**TO:** Members of the Planning and Zoning Commission  
**FROM:** Claudia D. Husak, AICP, Planner II  
**DATE:** July 17, 2008  
**RE:** WORK SESSION – Application No. 08-053INF – NE Quad, Subarea 3 –  
Wyandotte Woods Multi-Family – Wyandotte Woods Boulevard/Emerald  
Parkway  
**APPLICANT:** Homewood; represented by Smith and Hale & Kontogiannis Architects

## 6. WORK SESSION ITEM

Development Context  
Wyandotte Woods Multi-Family

*Figure 4: People should not be forced into the streets. Pedestrian access within a development and to the surrounding network should be a minimum design expectation.*

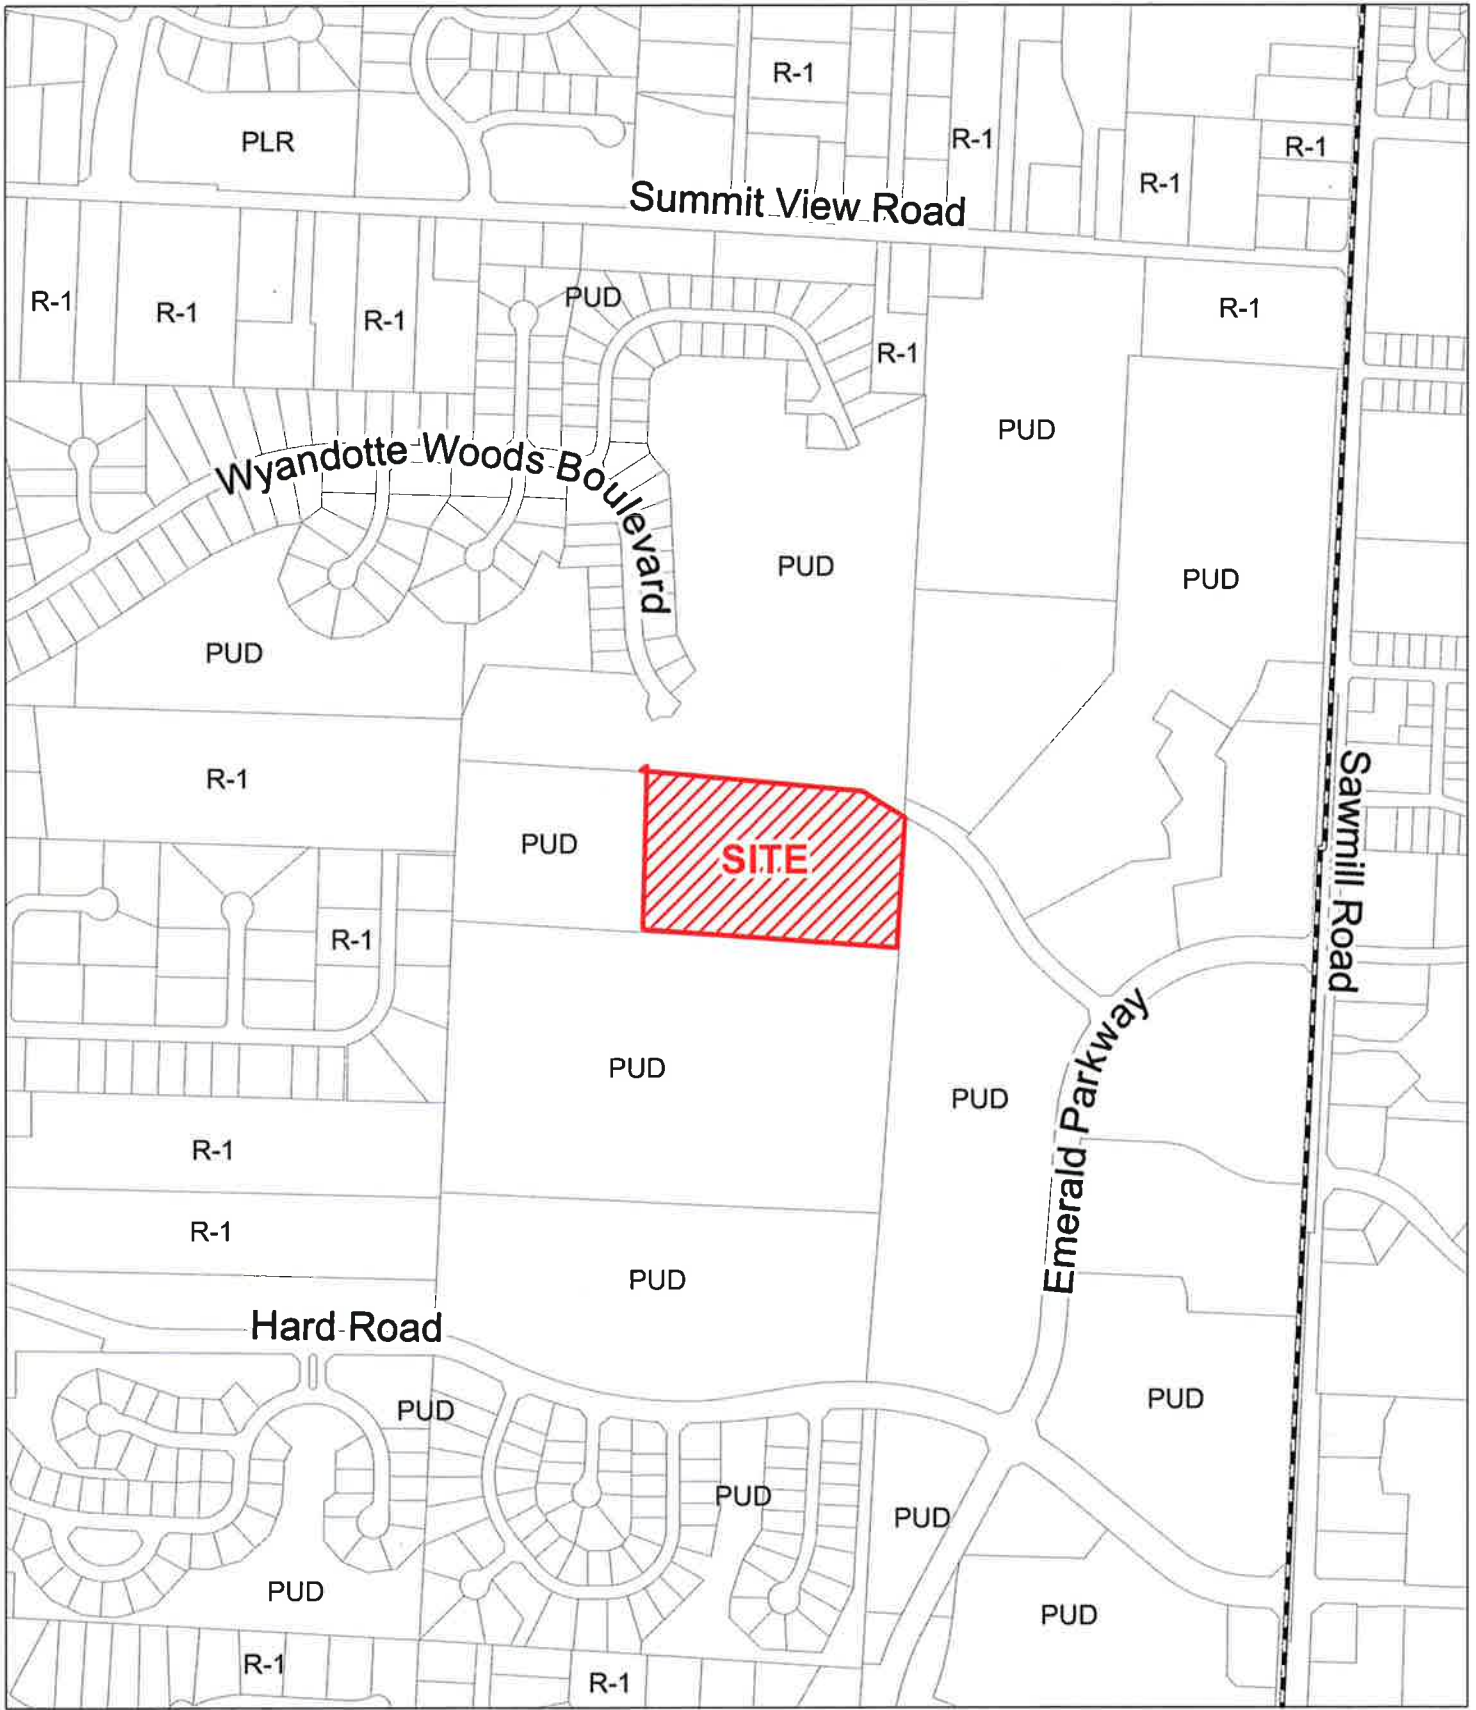
*Should the plan be modified to encourage on-street parking and an adequate streetscape design that will improve internal pedestrian mobility and connectivity to surrounding areas?*
